# Access Compliance Report

## Public Rights-of-Way

Intersection ID: 5741	Main Street: MALLARD_CREEK_RD	Cross Street: NEVIN_RD	Location: S
ADA ID: 40FFB51304F3	Ramp Type: MedianPerp	Initial Pass/Fail: Fail	Overall Compliance: No
		Severity Score: 1.25

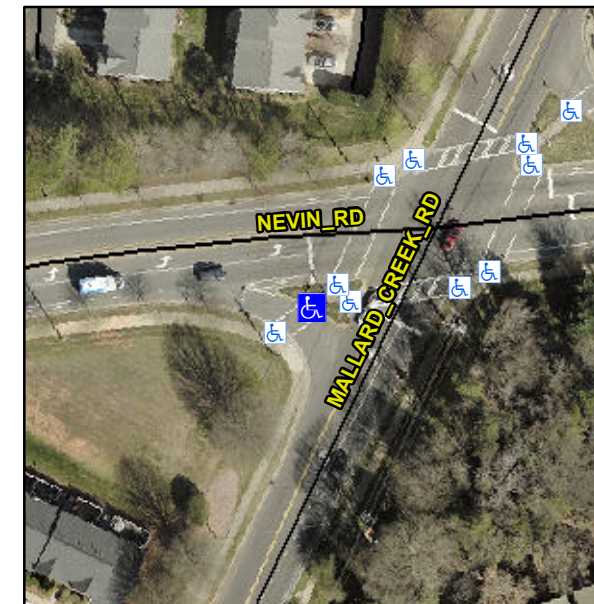
**Not Found, R304.5.3**

Compliance	Description	Data	Compliance	Description	Data
N/A	Ramp Length (in)	28.0	Yes	Ramp Slope (%)	5.2
Yes	Ramp Width (in)	70.0	No	Ramp XSlope (%)	3.2
N/A	Flare Type LT	N/A	N/A	Flare Type RT	N/A
N/A	Flare Slope LT (%)	N/A	N/A	Flare Slope RT (%)	N/A
N/A	Flare Traversable LT?	N/A	N/A	Flare Traversable RT?	N/A
N/A	Landing Length (in)	N/A	N/A	DWS Provided?	N/A
N/A	Landing Width (in)	N/A	N/A	DWS Contrast?	N/A
N/A	Landing Slope (%)	N/A	N/A	DWS Length (in)	N/A
N/A	Landing X Slope (%)	N/A	N/A	DWS Full Width?	N/A
N/A	Landing Curb? (Y/N)	N/A	N/A	DWS Offset (in)	N/A
N/A	Shared Landing?	N/A			
N/A	Gutter Ponding?	N/A	N/A	Gutter Slope (%)	N/A
N/A	Gutter Lip Ht (in)	N/A	N/A	Gutter X Slope (%)	N/A
N/A	Painted X Walk1?	Yes	N/A	Painted X Walk2?	N/A
	X Walk 1 Direction	To SW		X Walk 2 Direction	N/A
N/A	X Walk 1 Width (in)	130.0	N/A	X Walk 2 Width (in)	N/A
	X Walk 1 Slope (%)	0.9		X Walk 2 Slope (%)	N/A
	X Walk 1 X Slope (%)	2.5		X Walk 2 X Slope (%)	N/A

**Remove & Replace Entire Ramp.**
